PHOENIX HOMES

ROSEMERE-2012-E

SITE: PATHWAYS

CIVIC ADDRESS:
909 OMAGAKI WAY

footprint:	C10E
drawn by:	PL
date:	AUG/00
scale:	3/16"=1'-0"
sheet no:	1
	2

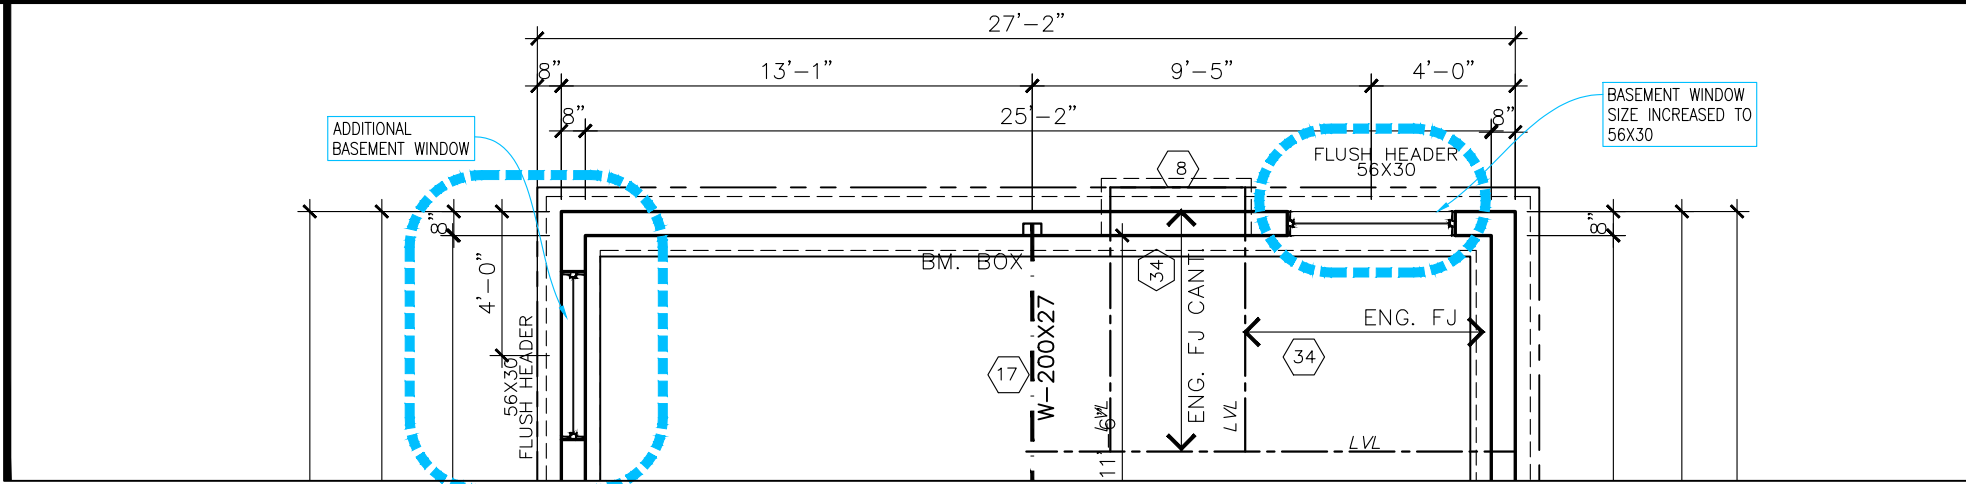
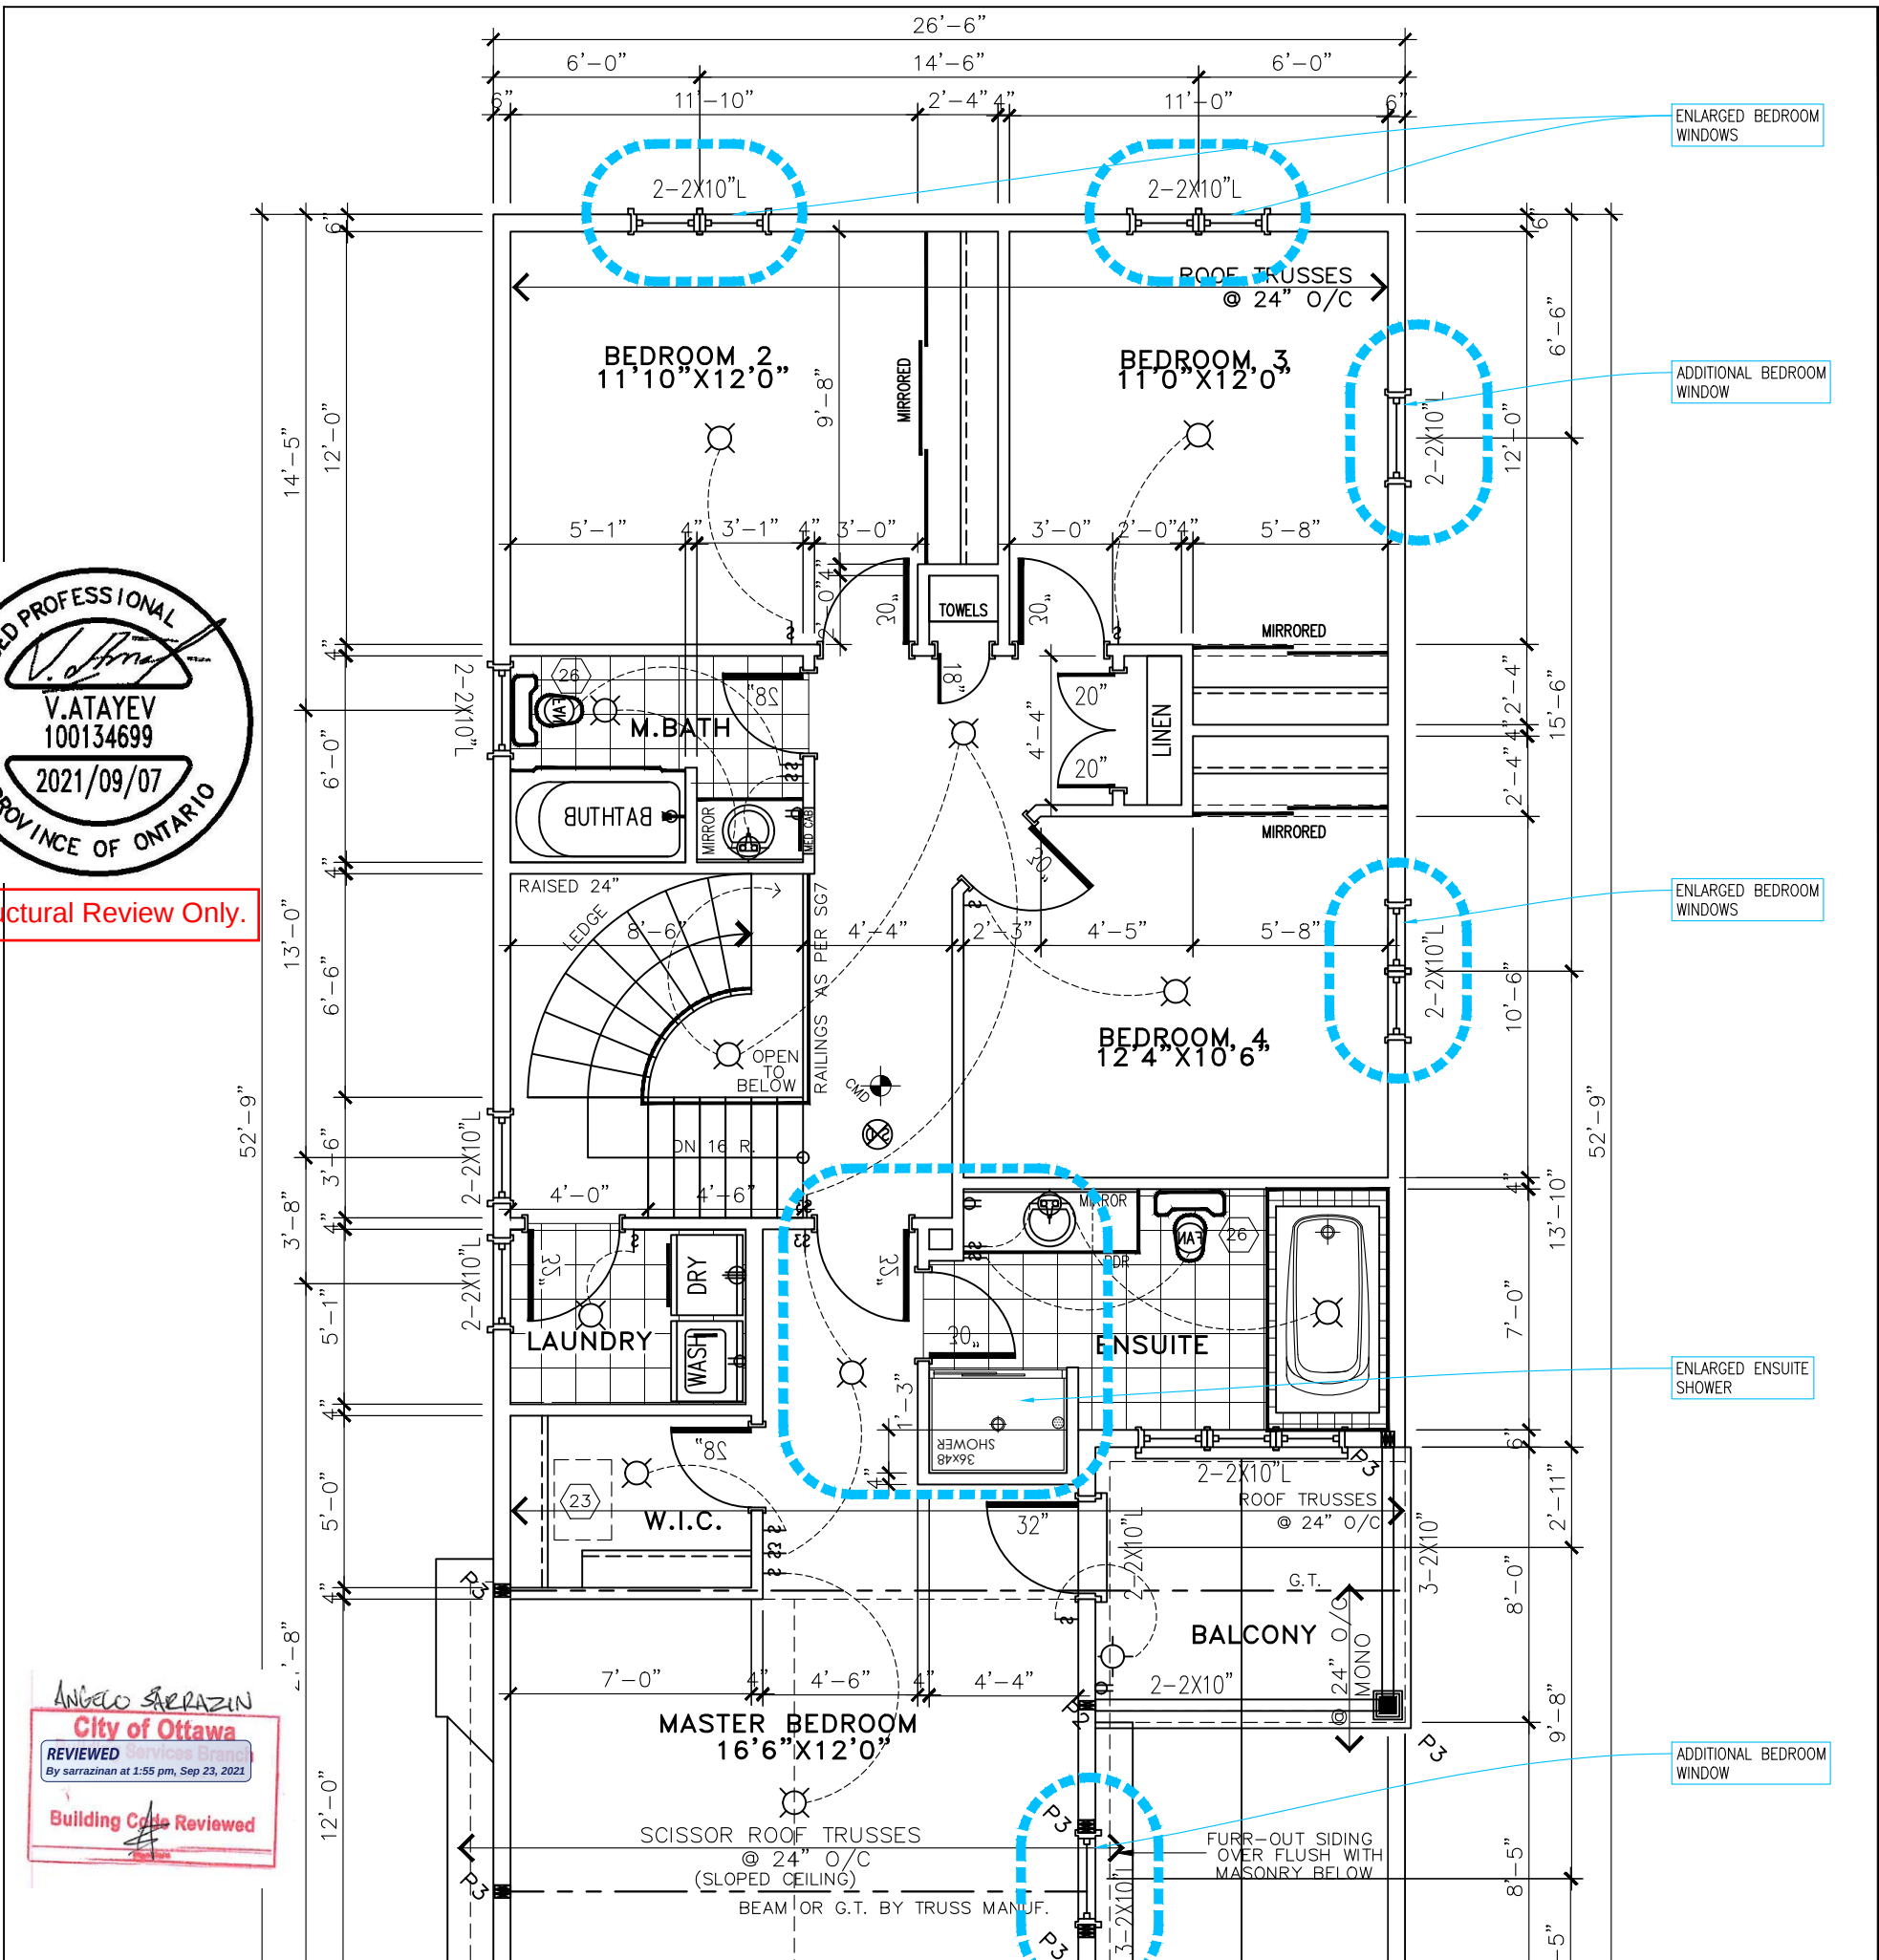
No.	Description	dd/mm/yy	By
2	ENGINEER MARKUPS APPLIED	XX/XX/XX	CB
1	ADDED BSMT WINDOW & ENLARGED BED WINDOWS	16/08/21	CB

sheet no: 2

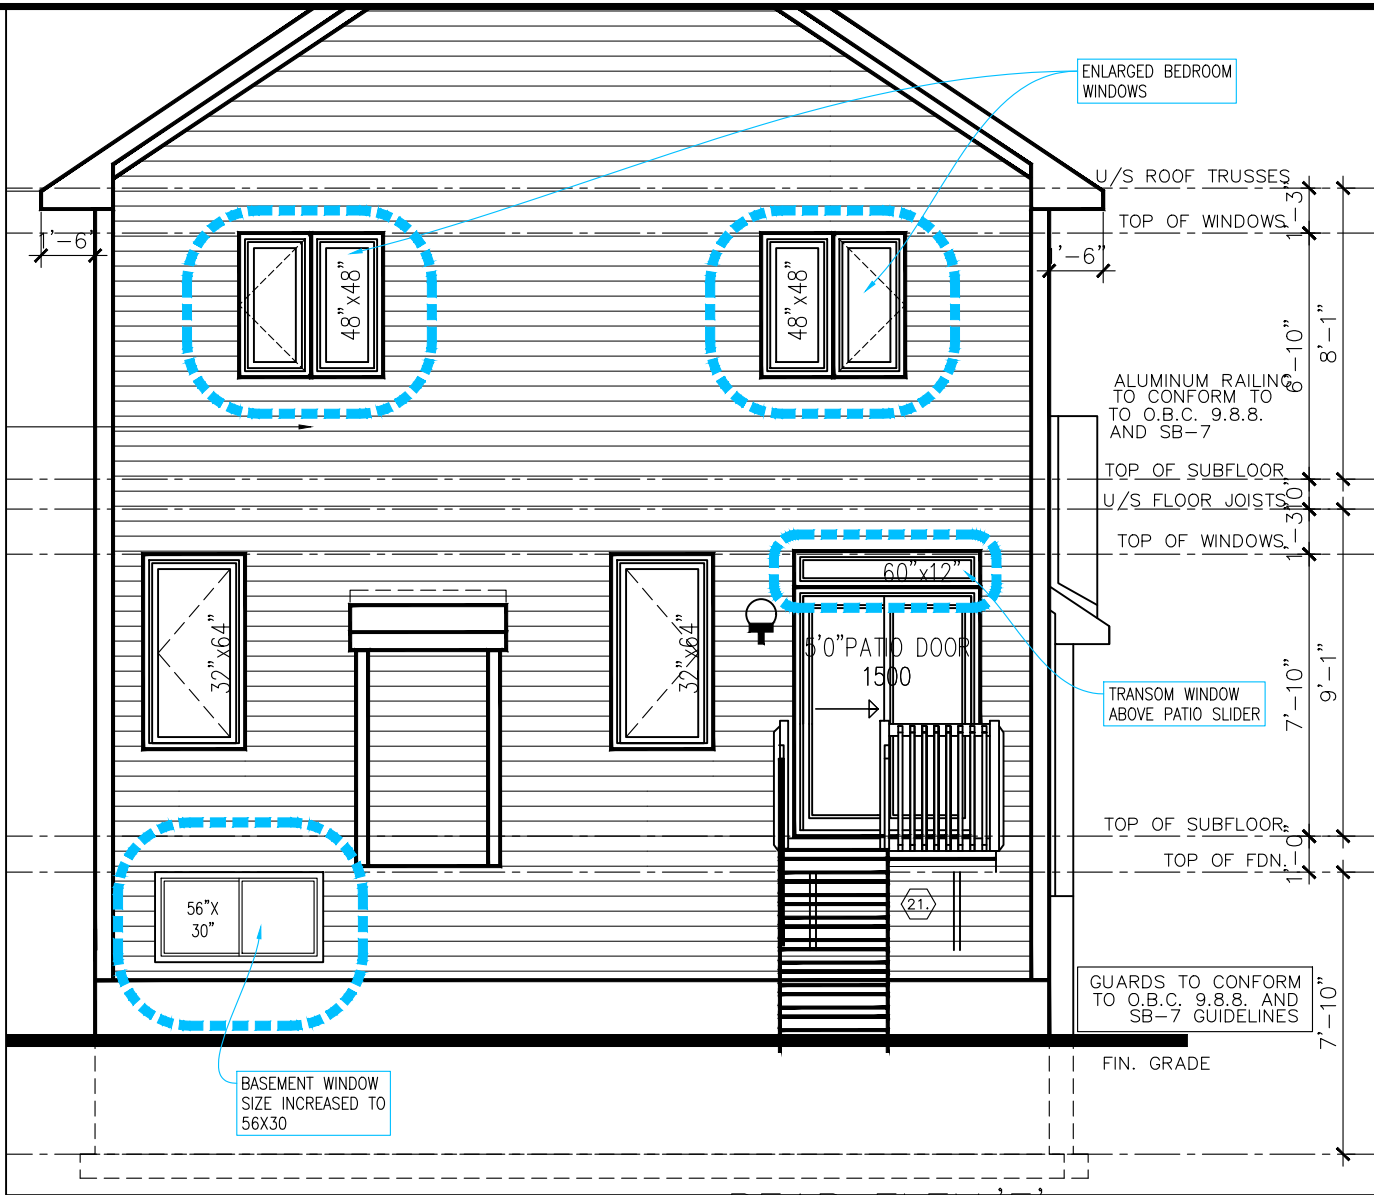
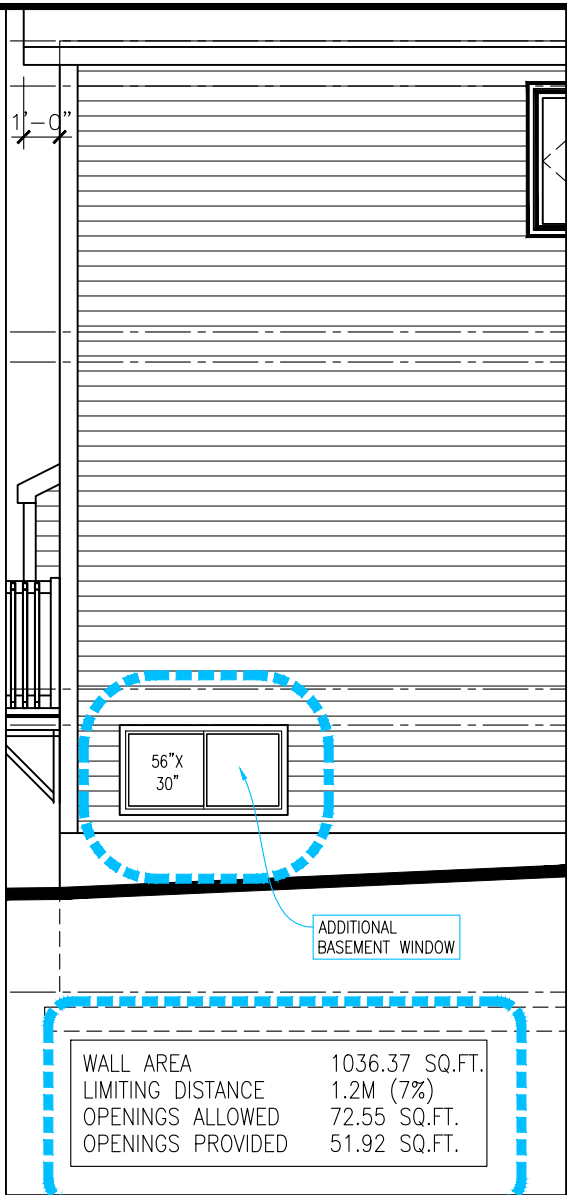
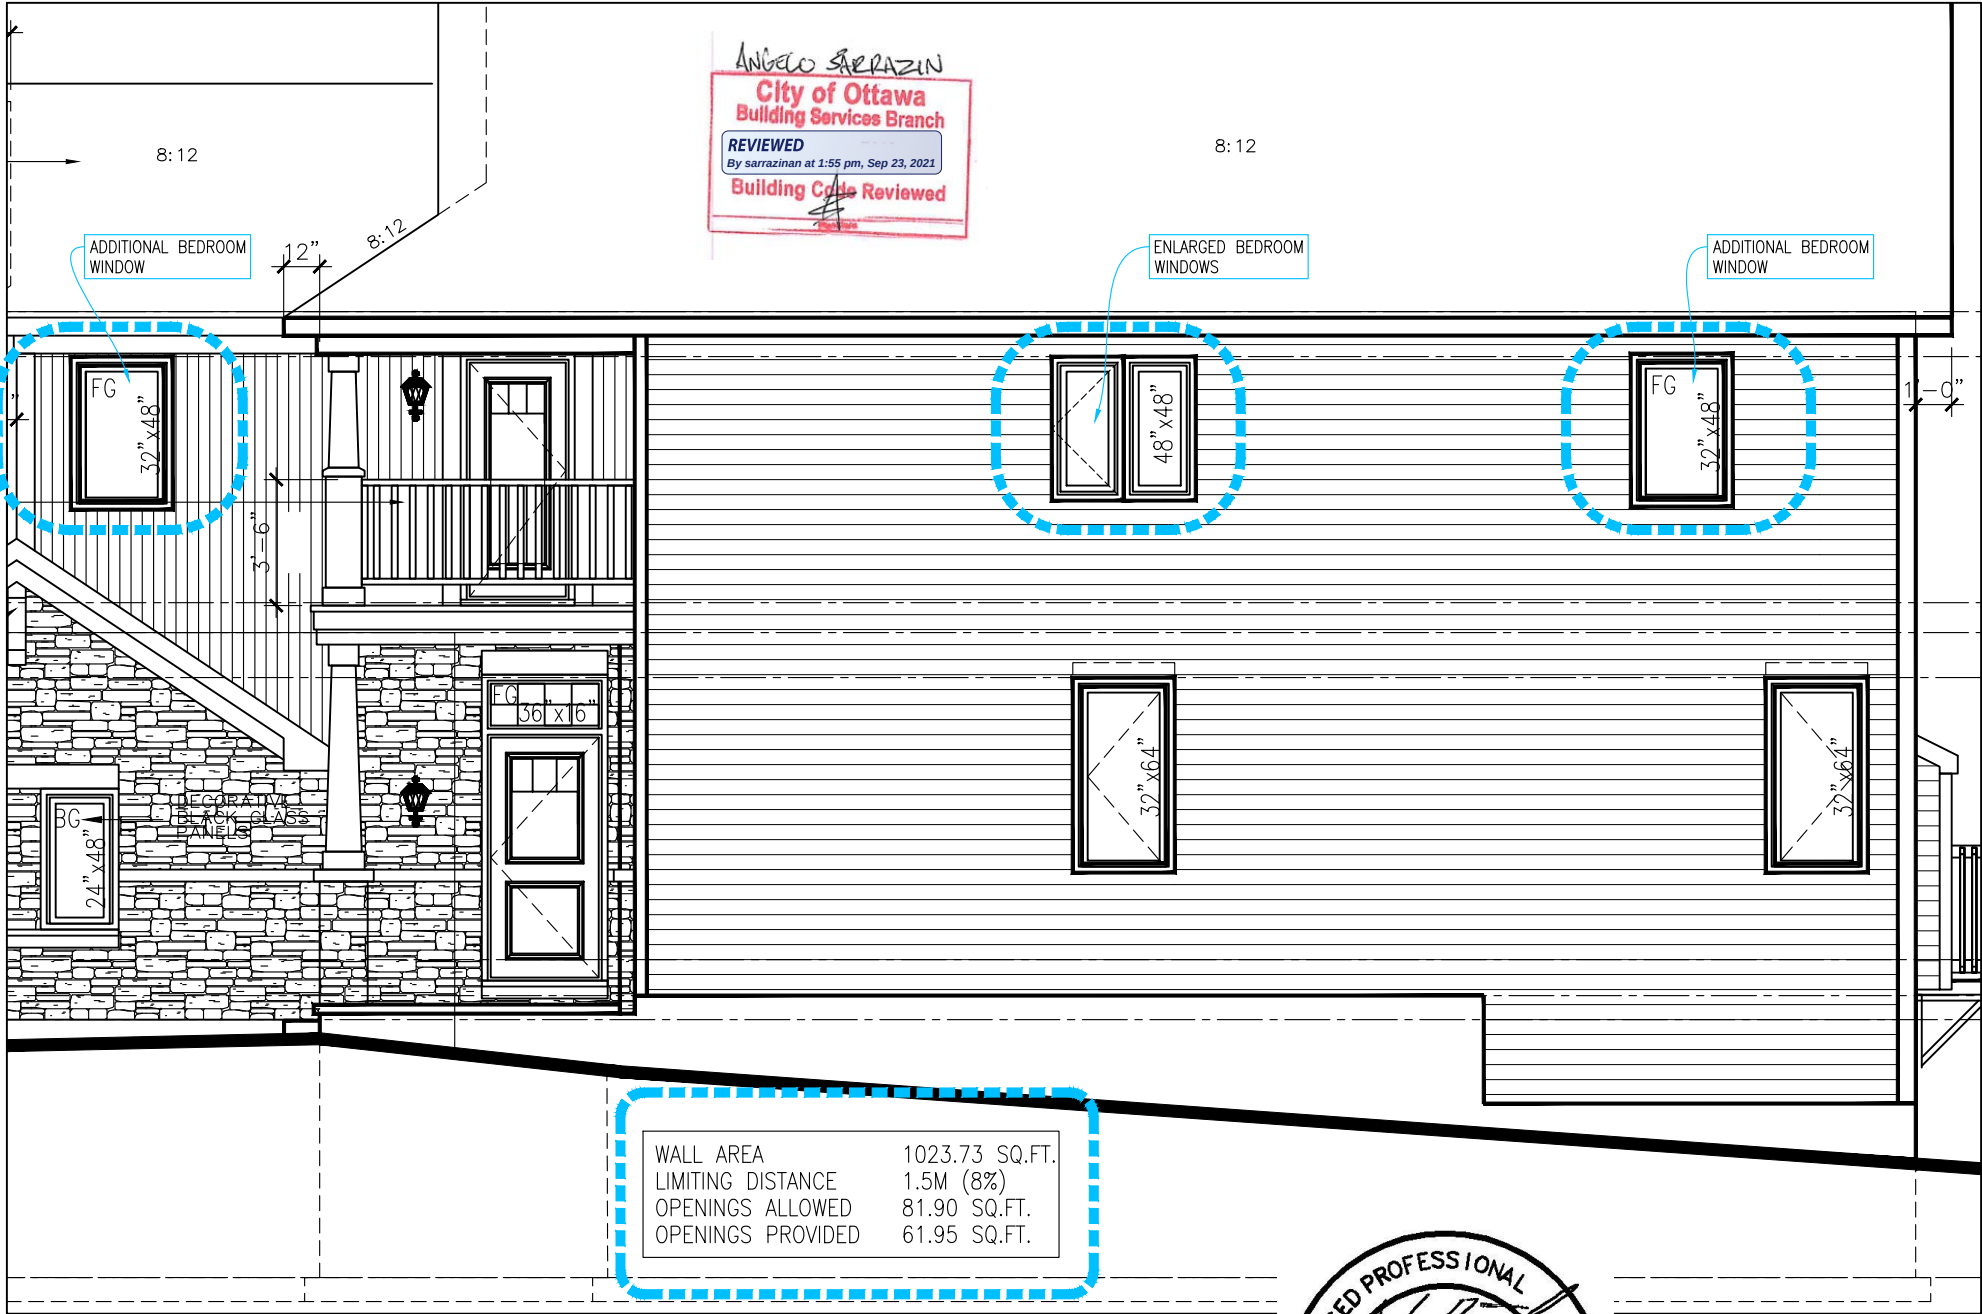
Structural Review Only.			
2	ENGINEER MARKUPS APPLIED	XX/XX/XX	CB
1	ADDED BSMT WINDOW & ENLARGED BED WINDOWS	16/08/21	CB
No.	Description	dd/mm/yy	By
REVISIONS
